UNITED STATES PATENT AND TRADEMARK OFFICE

APPLICATION NO.	FILING DATE	FIRST NAMED INVENTOR	ATTORNEY DOCKET NO.	CONFIRMATION NO.
10/774,876	02/10/2004	Richard Wayne Corbitt		8795

Office Action Summary

DETAILED ACTION

Mignano, Figure 4

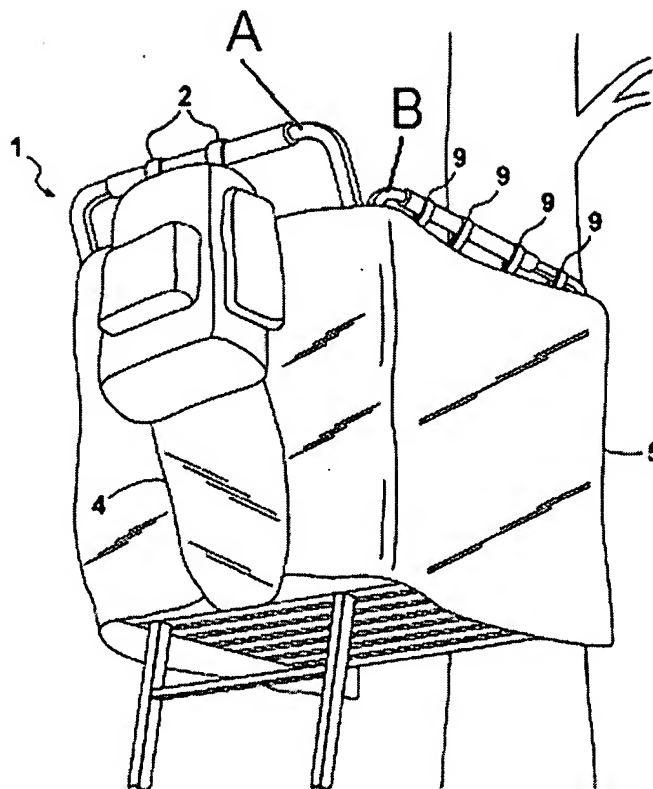
b. Regarding Claim 1, Mignano teaches a rigid frame (A, as seen in Figure 4, below) that supports a backpack (1) and a concealment blind (5) from an elevated tree stand position.

- c. Regarding Claim 2, Mignano teaches entry compartments (6) on the user side, facing an occupant of the blind.
- d. Regarding Claim 3, Mignano teaches that the frame hangs in a vertical position (best seen in Figure 4).
- e. Regarding Claims 4 and 5, Mignano teaches a backpack (1) and two permanently attached concealment blinds (5).

- f. Regarding Claim 6, Mignano teaches a backpack (1) that converts into a concealment blind (best seen in Figure 2).
- g. Regarding Claim 7, Mignano teaches that the backpack retains its function and utility as a pack (best seen in Figure 4).
- h. Regarding Claim 8, Mignano teaches that the backpack is part of the blind when in use (best seen in Figures 2 and 4).
- i. Regarding Claim 9, Mignano teaches a concealment blind (5) and a pack (1) that hangs outside of a tree stand's user space (Best seen in Figure 4).
- j. Regarding Claim 10, Mignano teaches a weapon/equipment holder (B) located on top of the frame (the upper side of the frame at B can be used to hold equipment).
